## 7.1.2 319-321 SPRINGVALE ROAD, GLEN WAVERLEY - USE AND DEVELOPMENT OF A FOUR-STOREY MEDICAL CENTRE, CARPARK AND SIGNAGE

That Council resolves to issue a Notice of Decision to Grant a Planning Permit TPA/54600 for the use and development of a three-storey medical centre with two basement levels, display of signage and reduction in the car parking requirement at 319-321 Springvale Road, Glen Waverley subject to the following conditions:

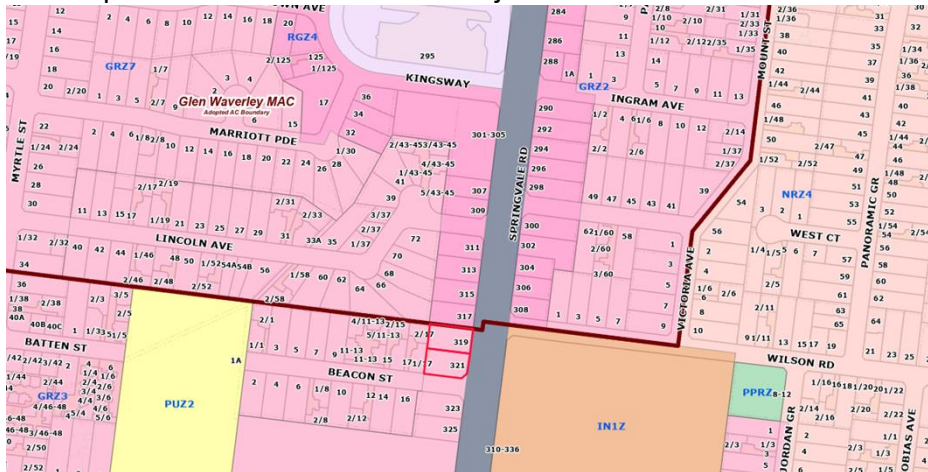
Council's Senior Arborist assessed the two street trees in Beacon Street, and advised that the proposed vehicle crossover should be setback a minimum of 3.5 metres from the adjacent street tree (western tree No.1 - *Melaleuca styphelioides*).

The proposed crossover is recommended by Council's Transport Engineer to be widened to 5.5 metres. A 3.5 metres from the subject street tree will be provided and has been put as a condition 1 requirement.

*Overlooking diagram to 17 Beacon Street provided by Applicant*

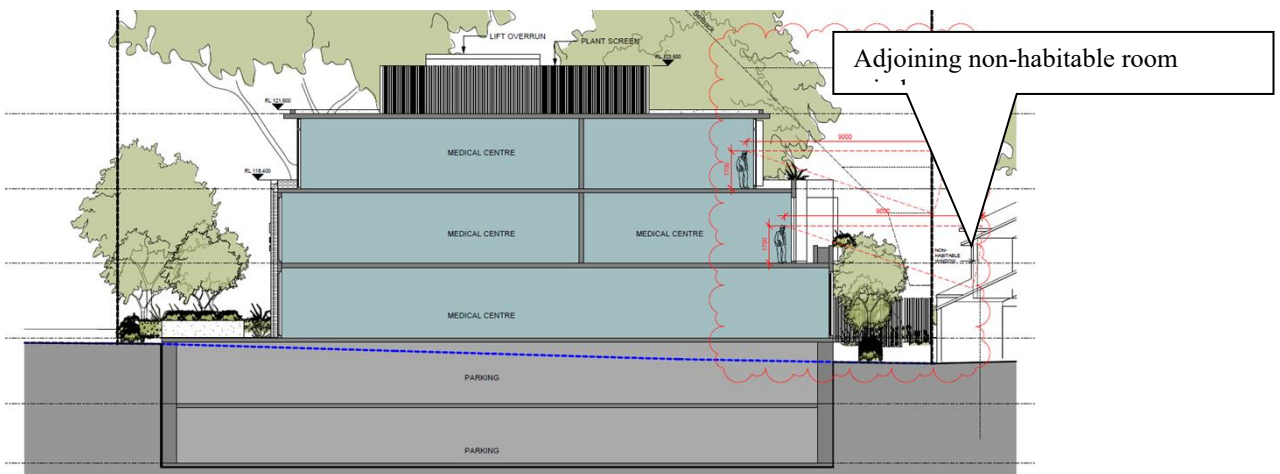
Whilst the planning scheme does not specify measures for overlooking for a non-residential use, the tools in the Overlooking Objectives of Clauses 54 and 55 are useful guides for ensuring views into existing secluded private open space and habitable room windows do not impact surrounding

residential amenity. The Applicant has submitted overlooking diagrams demonstrating how overlooking is prevented. The diagrams show the use of obscure glazing and planters on the upper levels to avoid overlooking which would satisfy the relevant requirements of the Overlooking objectives.

**Overshadowing**

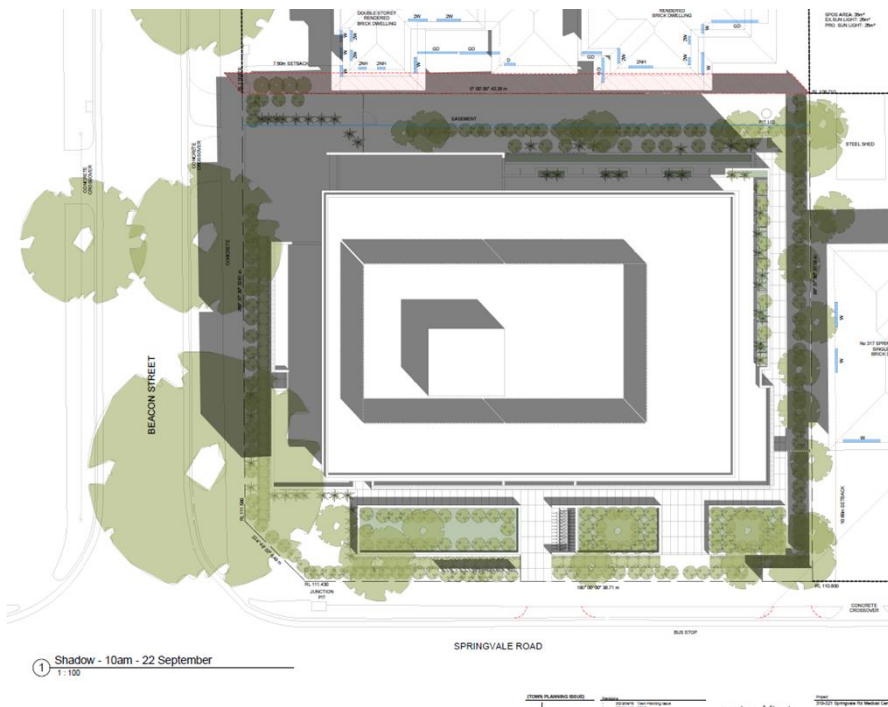
Overshadowing can be considered using the measures of Clauses 54 and 55 (Overshadowing Open Space Objective). The proposal will cause additional shadow to the adjoining secluded private open space to the west at 9am, and then the shadow will fall within the existing fence shadow from 10am onwards. A minimum of 75% of the adjoining secluded private open space will receive five hours of sunlight between 9am and 3pm on the September equinox, meeting the requirements of the Standard.

There will be no additional shadow to the north adjoining property or the footpaths in the streets.

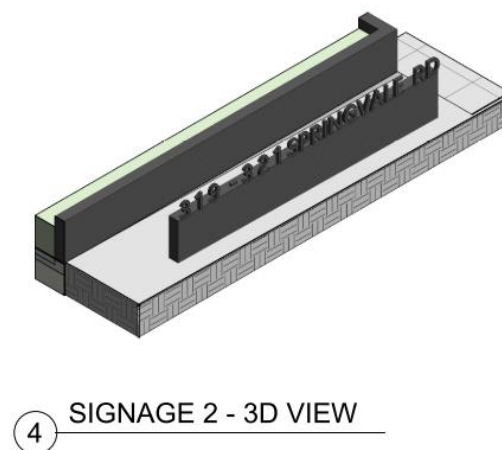
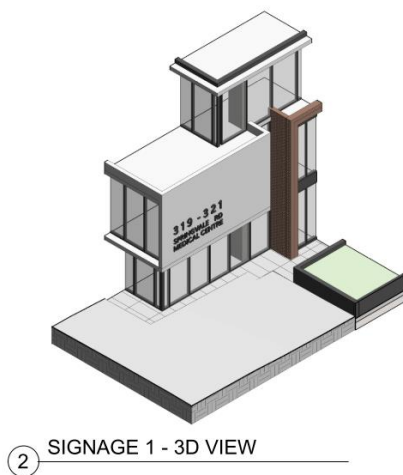
Council’s Traffic Engineer agrees with the assessment of Impact Traffic Engineering and advised that there are enough short-term spaces along Beacon Street outside the development to cover the parking shortfall of car parking spaces, and the provision of 58 car spaces on the site is considered sufficient.

Additional line marking, and signage should be provided to avoid small vehicles parking at non-parking spaces which has been discussed in the Referral section.
